Darebin C161 Post Exhibition
 Highlighted underline/strikeout = post-exhibition changes

DAREBIN PLANNING SCHEME

SCHEDULE 21 TO CLAUSE 43.02 DESIGN AND DEVELOPMENT OVERLAY

FAIRFIELD VILLAGE NEIGHBOURHOOD CENTRE

Figure 1: Front setbacks with retained single storey building in Area 1

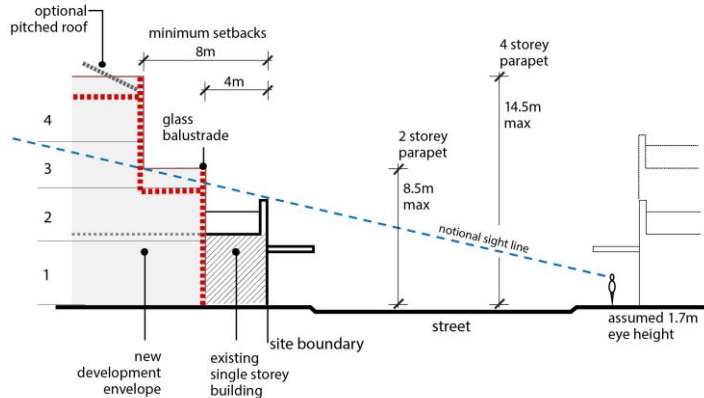
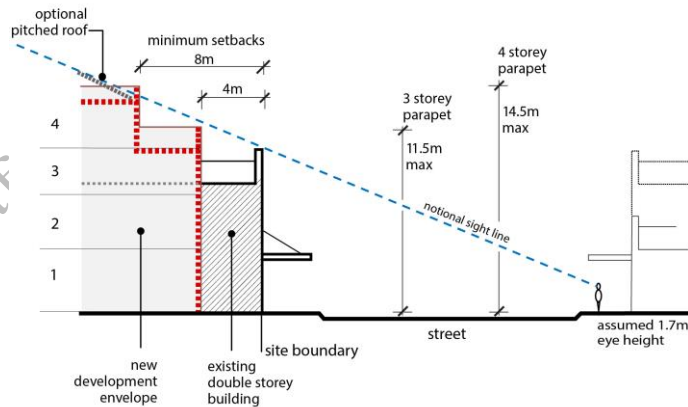
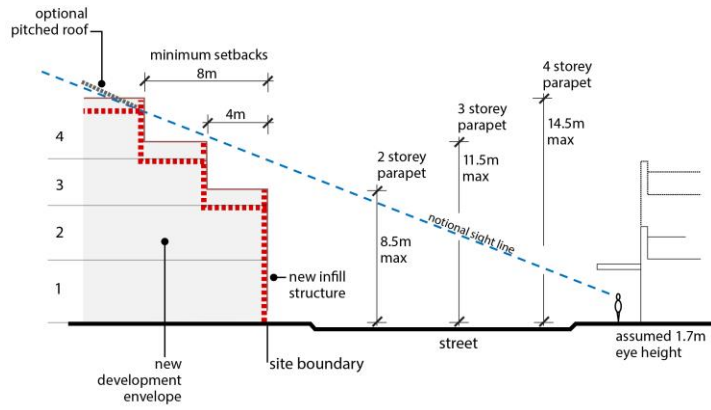
Balustrades to balconies or terraces which are visible behind retained historic street parapets from the street should be of clear glass, as shown in Figure 1. ~~The sight line angle shown on Figures 1, 2 and 3 is notional and depends on the varying heights of the existing street parapets and the exact position of the observer.~~

Commented [DW10]: Council agreed to delete sentence based on DELWP feedback but was not a tracked change in DELWP's document. The notional aspect of the figures were considered to be clear.

Figure 4: Front setbacks with retained valued street facade in Area 2

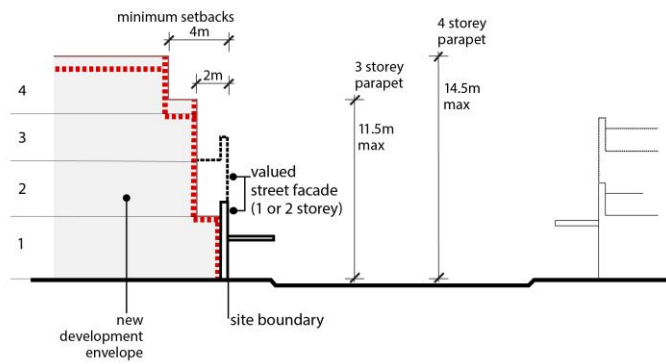
Commented [DW11]: Change made in response to submission.

Figure 7: Rear Setback Requirements

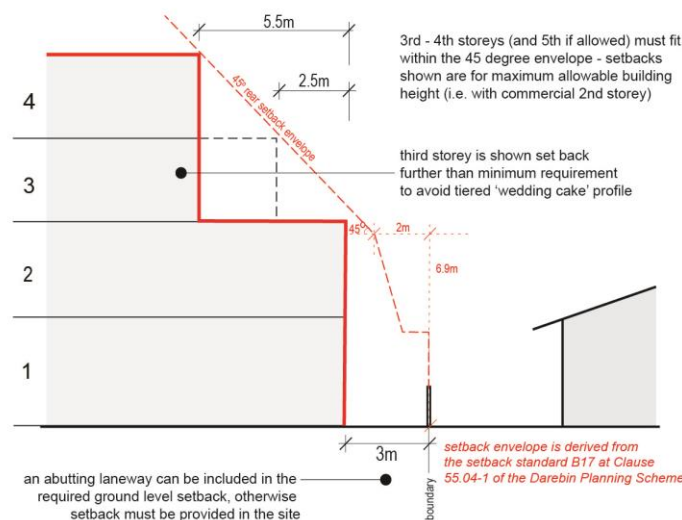
Commented [PM(13)]: Figure 7's setback is not in accordance with the provision detailed above.

The comment regarding setback B17 should be removed.

Commented [DW14R13]: Reference to B17 explains the basis for the setback requirement.
